Access Compliance Report

Public Rights-of-Way

Intersection ID: 53746	Main Street: SPRINGWOOD_ESTATE_DR	Cross Street: CANTERBURY_CASTLE_DR	Location: NW
ADA ID: 80841AA5FDB8	Ramp Type: BlendTrans1	Initial Pass/Fail: Fail	Overall Compliance: No
Severity Score: 8.75			
Codes/Mitigation Info/Possible Solution		Field Measurements/Component Compliance

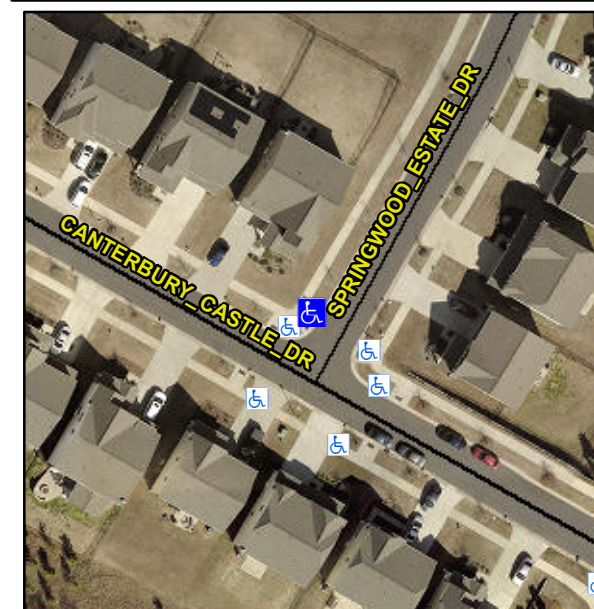
Not Found, R304.5.1

Compliance	Description	Data	Compliance	Description	Data
N/A	Ramp Length (in)	101.0	Yes	BlendTrans Slope (%)	0.7
No	Ramp Width (in)	41.5	Yes	BlendTrans XSlope (%)	1.8
N/A	Flare Type LT	N/A	N/A	Flare Type RT	N/A
N/A	Flare Slope LT (%)	N/A	N/A	Flare Slope RT (%)	N/A
N/A	Flare Traversable LT?	N/A	N/A	Flare Traversable RT?	N/A
N/A	Landing Length (in)	N/A	N/A	DWS Provided?	N/A
N/A	Landing Width (in)	N/A	N/A	DWS Contrast?	N/A
N/A	Landing Slope (%)	N/A	N/A	DWS Length (in)	N/A
N/A	Landing X Slope (%)	N/A	N/A	DWS Full Width?	N/A
N/A	Landing Curb? (Y/N)	N/A	N/A	DWS Offset (in)	N/A
N/A	Shared Landing?	N/A			
N/A	Gutter Ponding?	N/A	N/A	Gutter Slope (%)	N/A
N/A	Gutter Lip Ht (in)	N/A	N/A	Gutter X Slope (%)	N/A
N/A	Painted X Walk1?	No	N/A	Painted X Walk2?	N/A
	X Walk 1 Direction	To SE		X Walk 2 Direction	N/A
	X Walk 1 Width (in)	N/A		X Walk 2 Width (in)	N/A
	X Walk 1 Slope (%)	3.8		X Walk 2 Slope (%)	N/A
	X Walk 1 X Slope (%)	4.4		X Walk 2 X Slope (%)	N/A

N/A	Ramp inside XWalk1?	N/A	N/A	Ramp inside XWalk2?	N/A
	Road Slope (%)	4.4		Clear Space?	N/A
	Road X Slope (%)	3.8	N/A	Clear Space to XWalk (in)	N/A
N/A	Any Obstructions?	N/A	N/A	Storm Grate/Utility Hazard?	N/A
	Obstruction Type			Storm Grate/Utility Type	
		N/A			N/A
			Yes	Surface Condition? (G/P)	Good
			No	Curb Slope (%)	6.6

Remove & Replace Curb Ramp With Two New Directional Ramps or Equivalent.
